Portales Brown Early Childhood Center, Project #S20-008, PSFSA FUNDING

**APPROVED MECHANICAL**  
**TAMARA KUYKENDALL**  
Exceptions As Noted  
Checking is only for general conformance with the design concept of the plans and general compliance with the information given in the contract documents. Any omissions or corrections are subject to the requirements of the plans and specifications. Contractor is responsible for dimensions, materials and workmanship and compliance with the applicable codes and regulations. All work shall conform with the Uniform Mechanical Code and Plumbing Codes, any other applicable codes and the requirements of the Mechanical and Plumbing codes.  
02/28/2020 9:47:29 AM

**ELECTRICAL APPROVED - Kelly Larsen**  
Exceptions As Noted  
Checking is only for general conformance with the design concept of the plans and general compliance with the information given in the contract documents. Any omissions or corrections are subject to the requirements of the plans and specifications. Contractor is responsible for dimensions, materials and workmanship and compliance with the applicable codes and regulations. All work shall conform with the Uniform Electrical Code

**Brown Early Childhood Center  
Old Wing Renovation**  
520 W 5th St, Portales, NM 88130

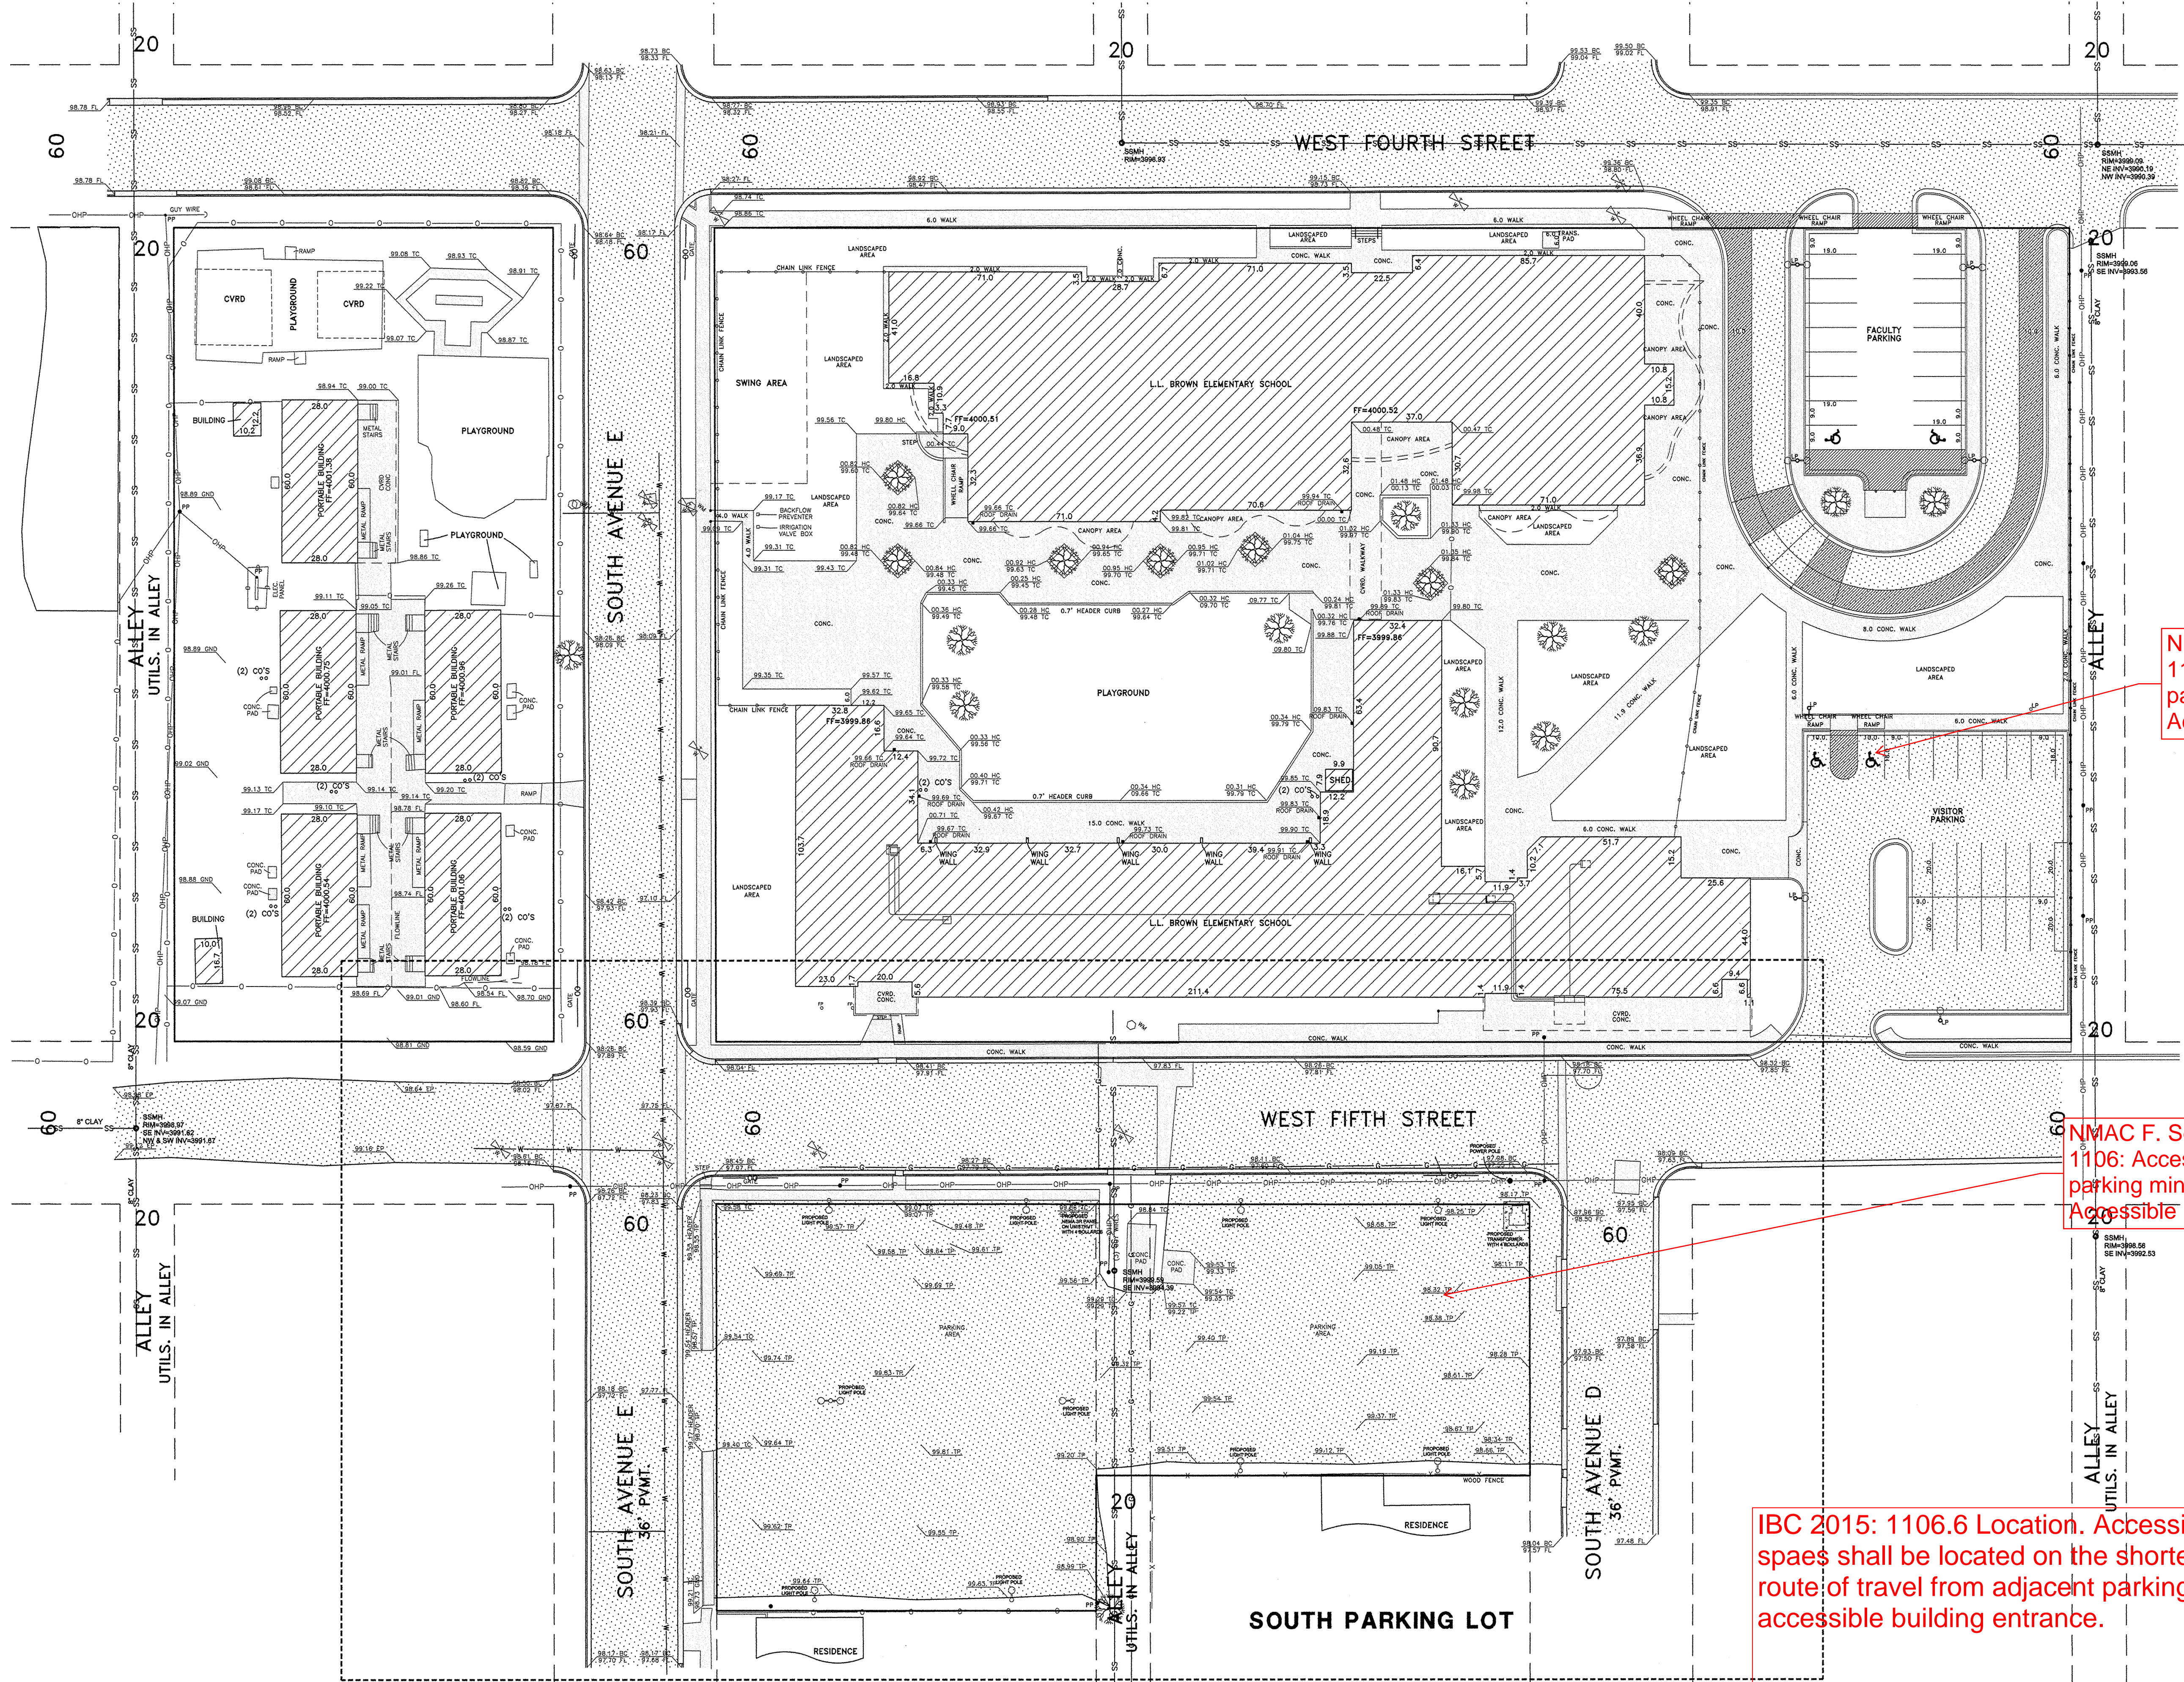
NMAC F. Section 1106: Accessible parking min. "Van Accessible" space

**A4 LIGHTING FLOOR PLAN - AREA B**

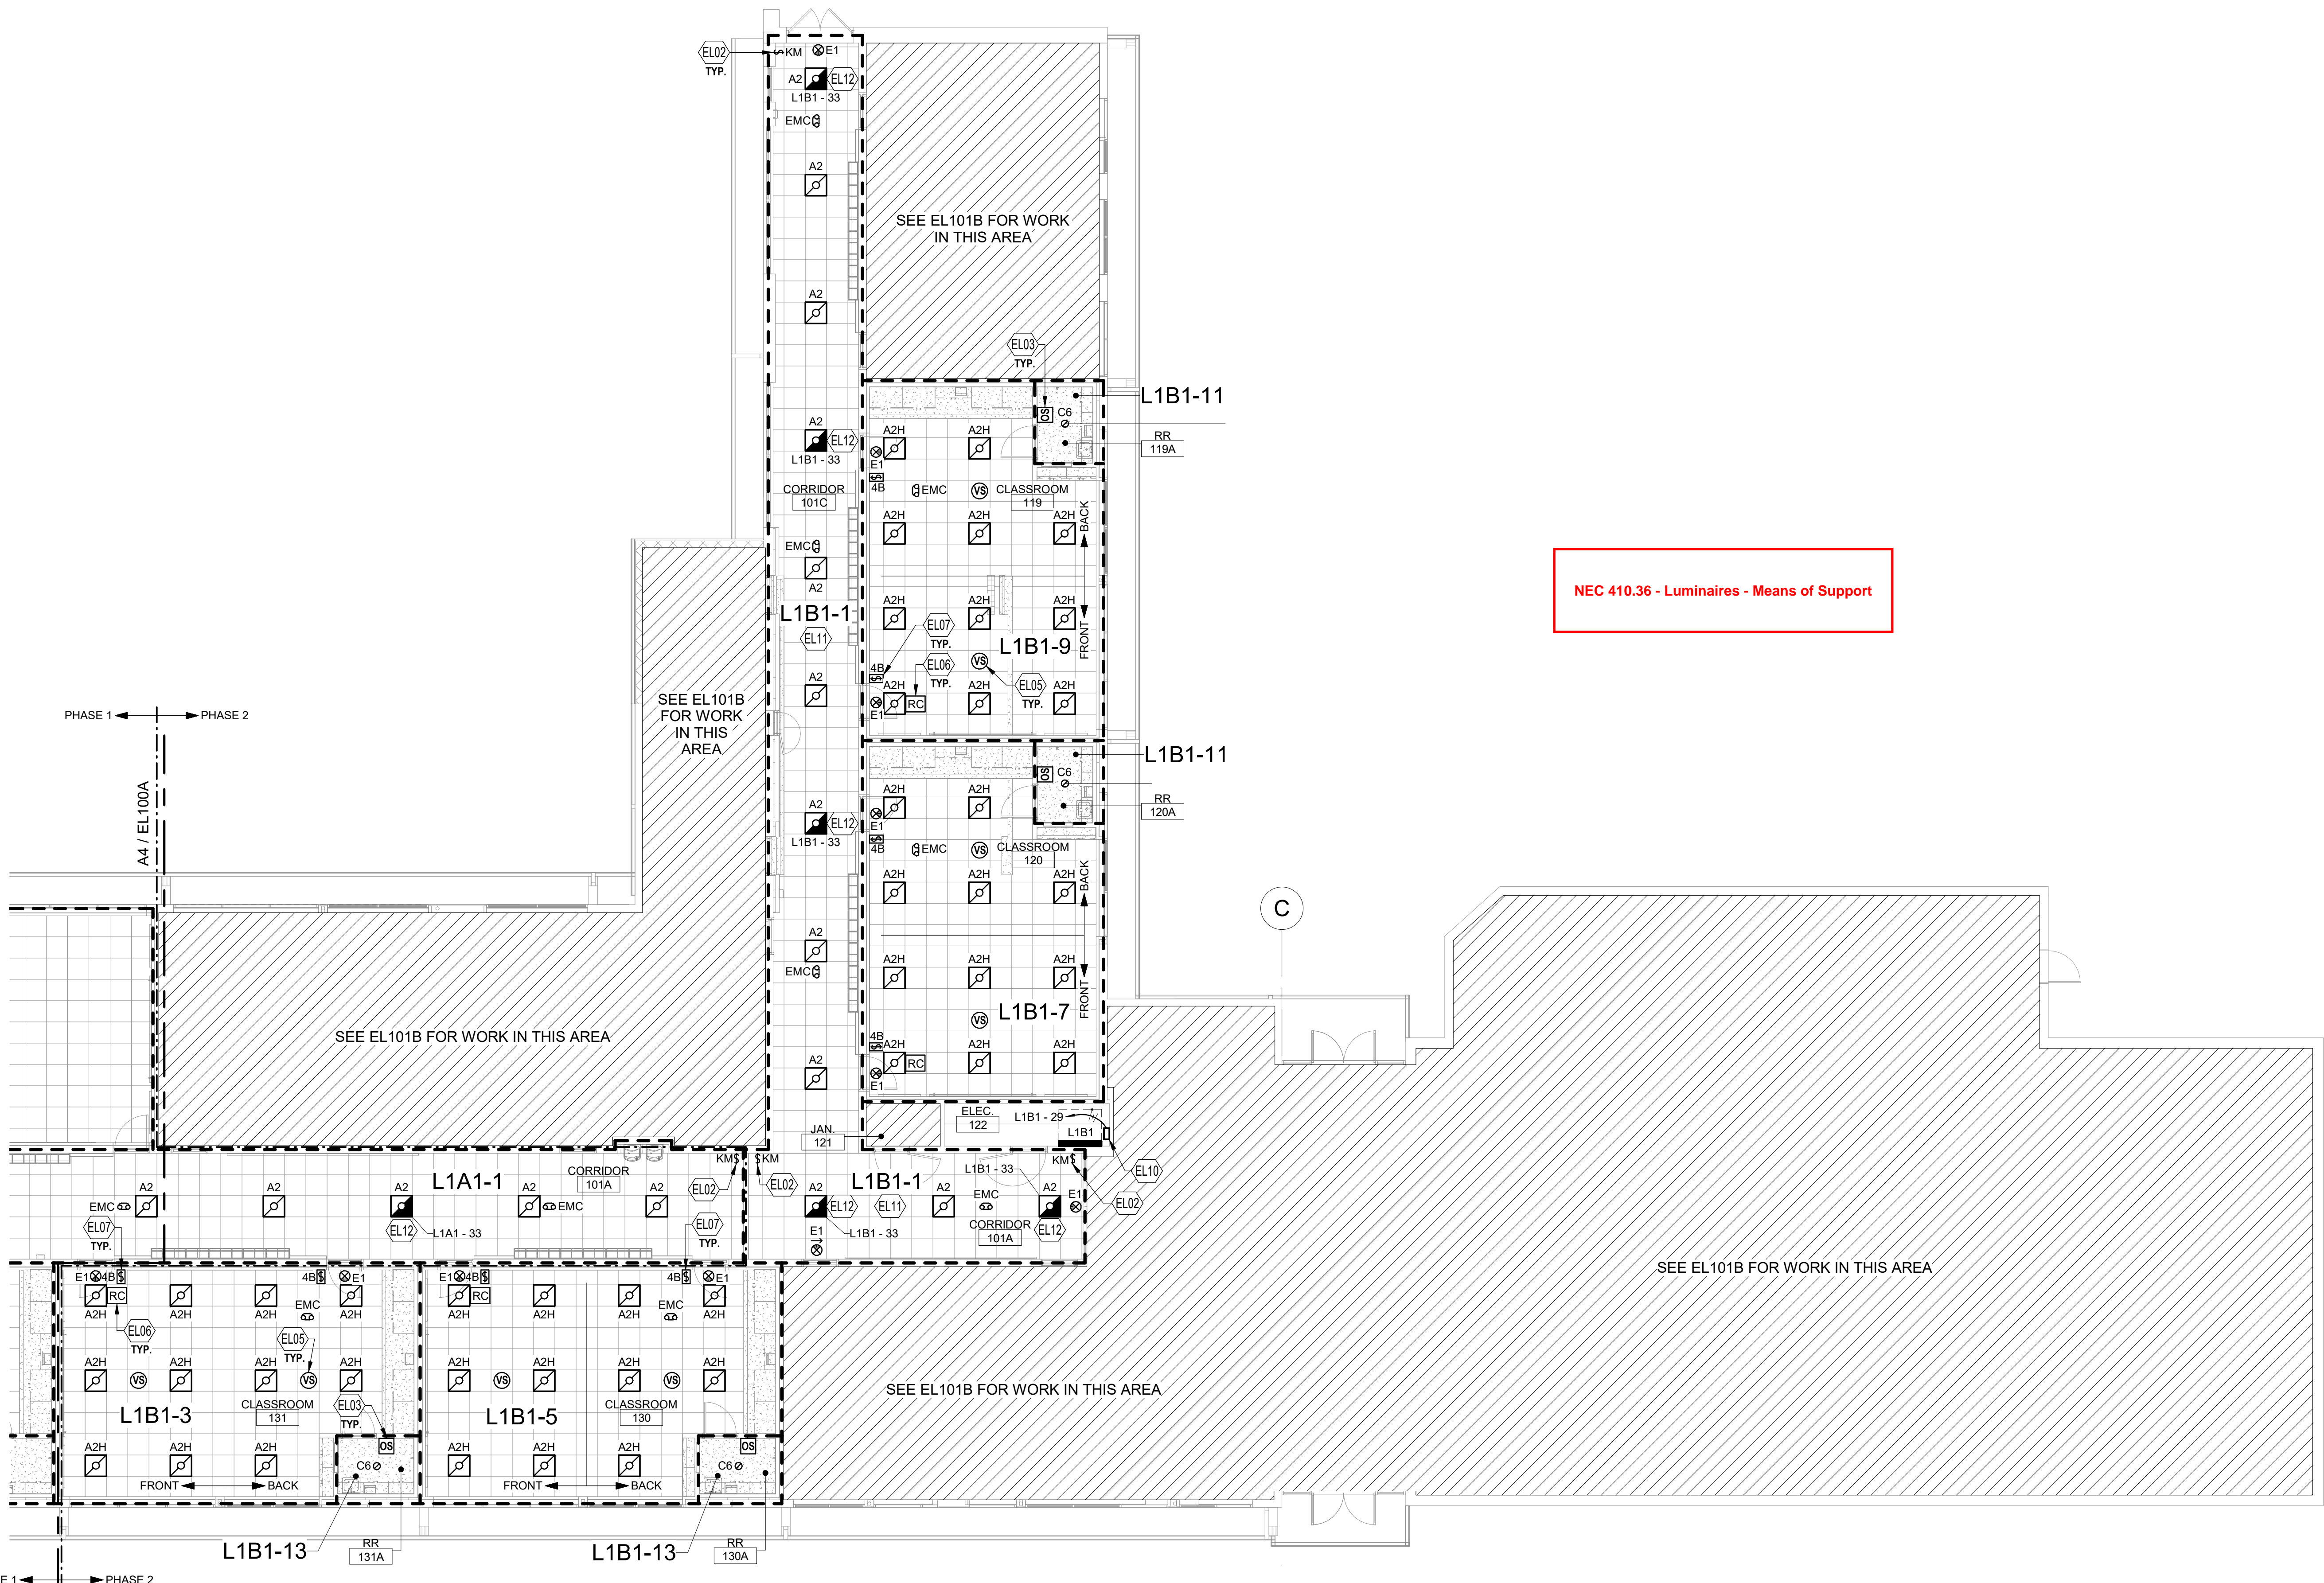
NEC 410.36 - Luminaires - Means of Support

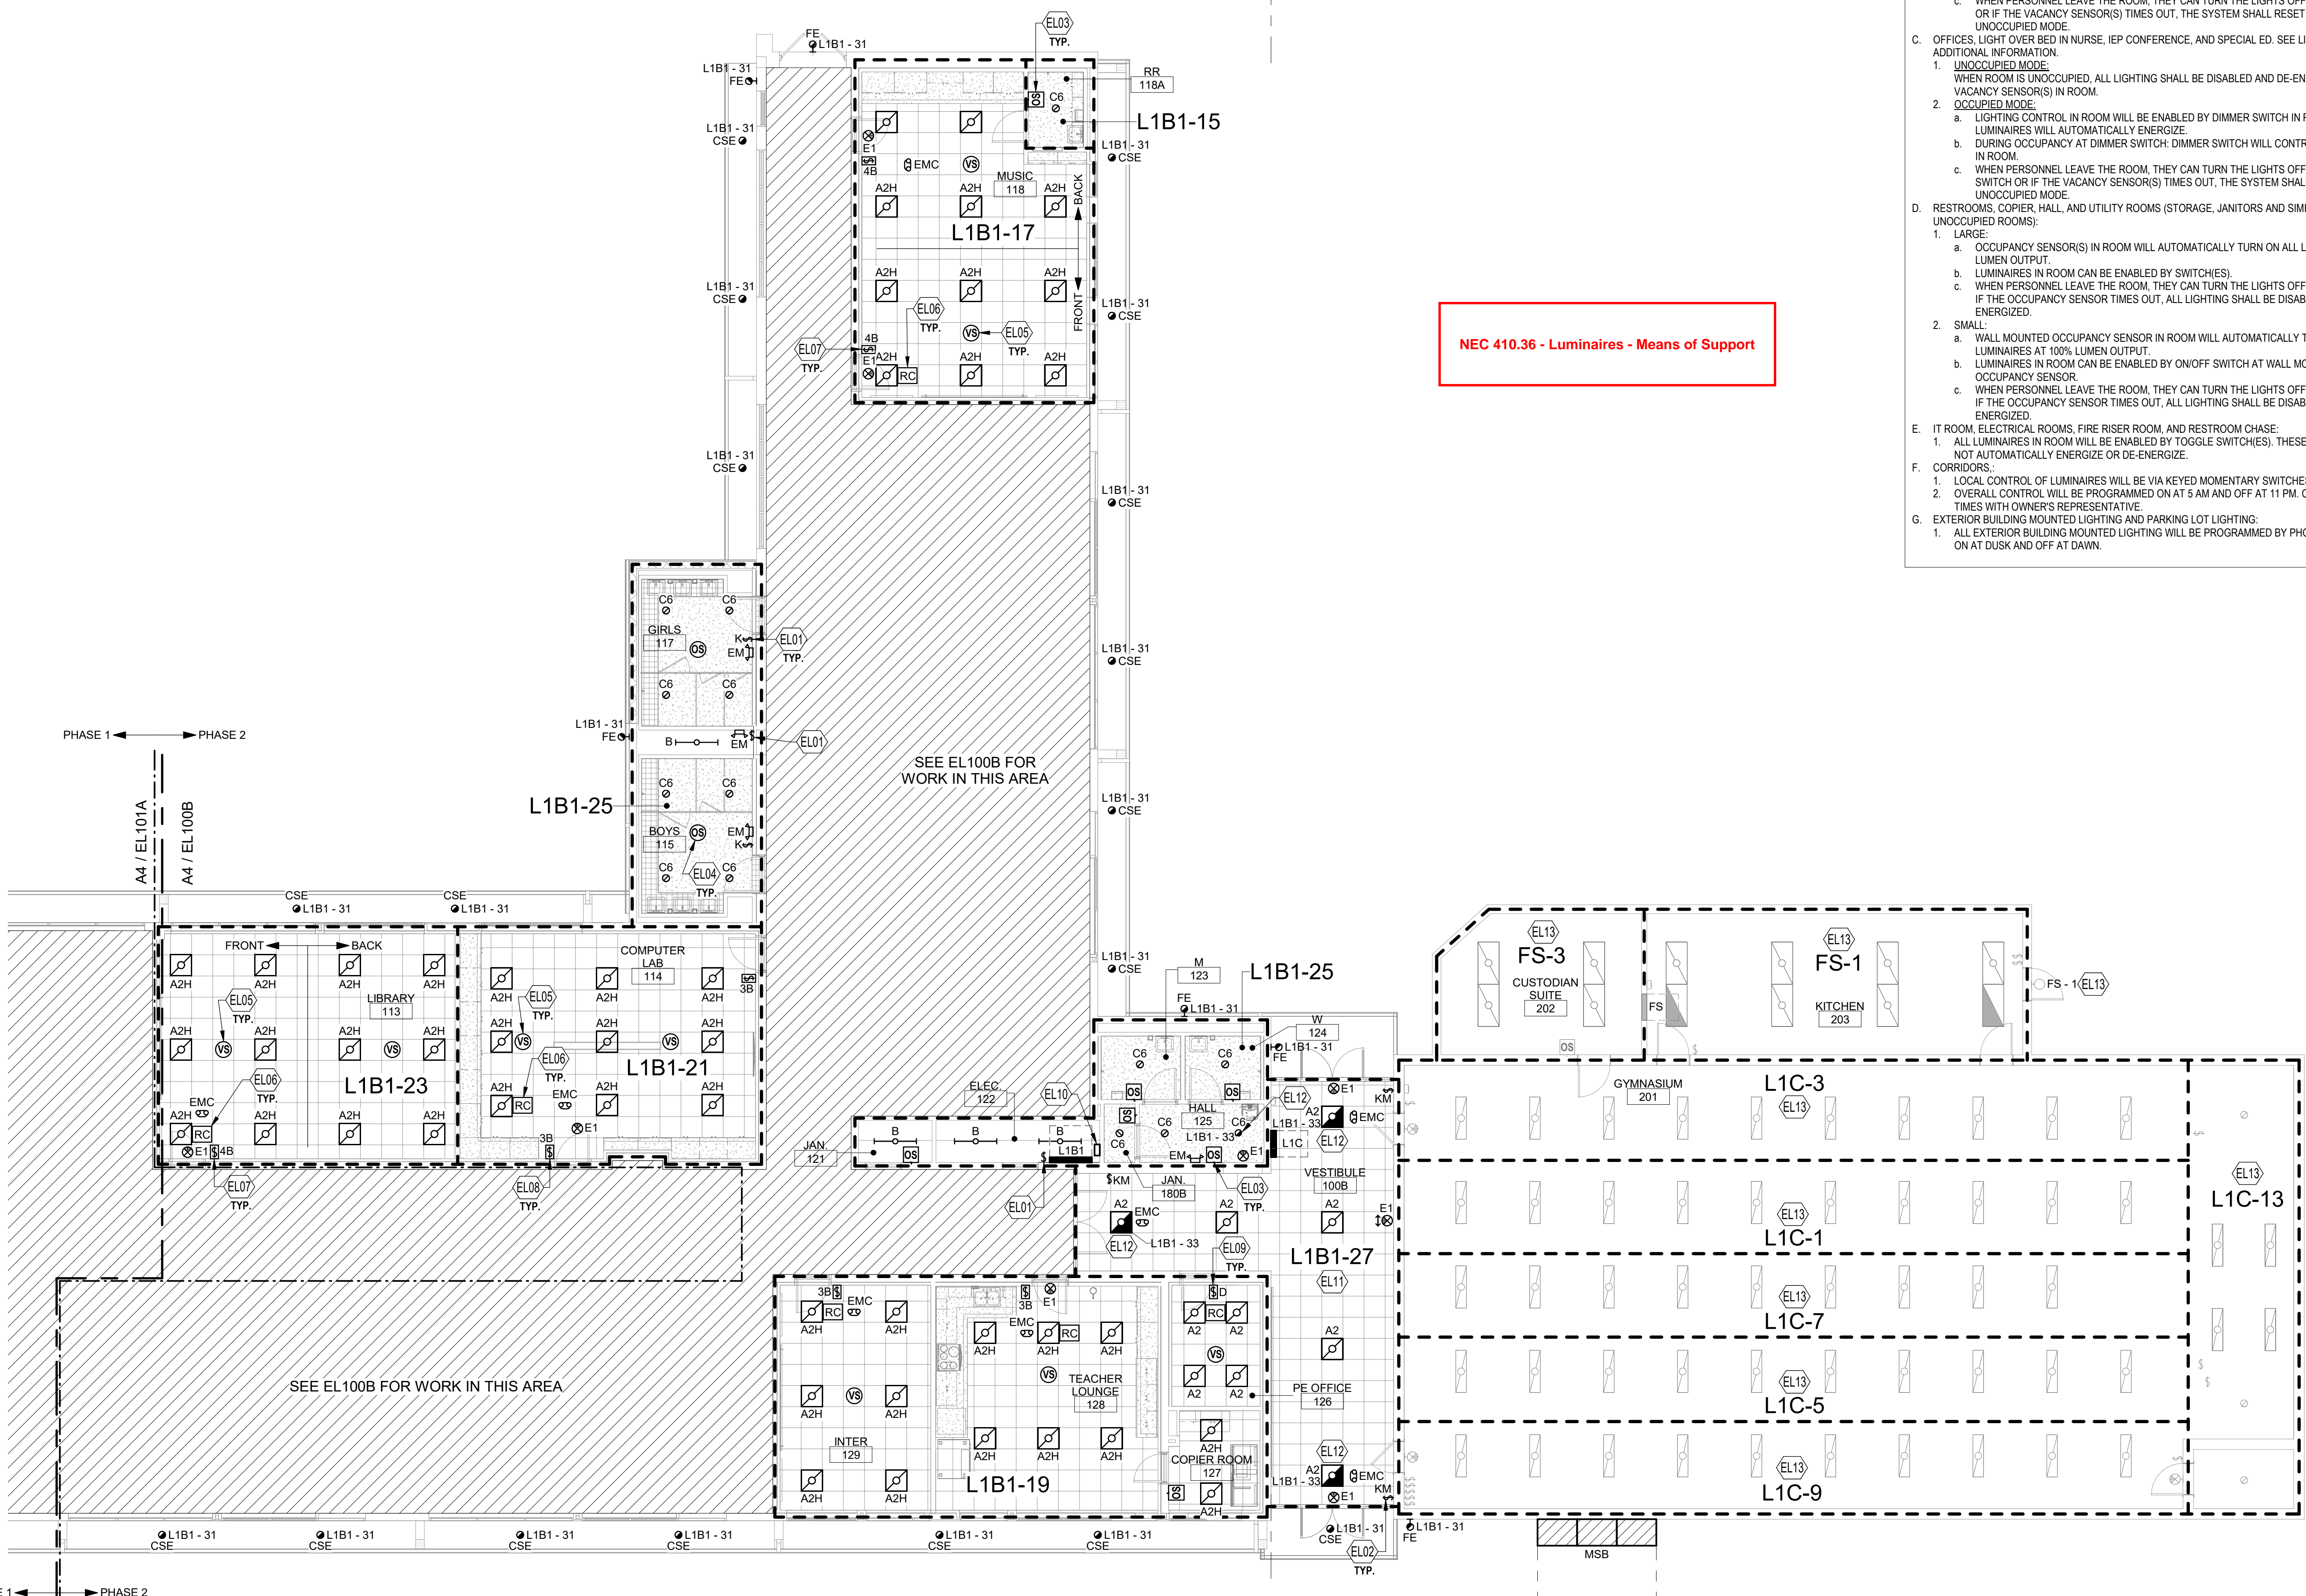
NEC 410.36 - Luminaires - Means of Support
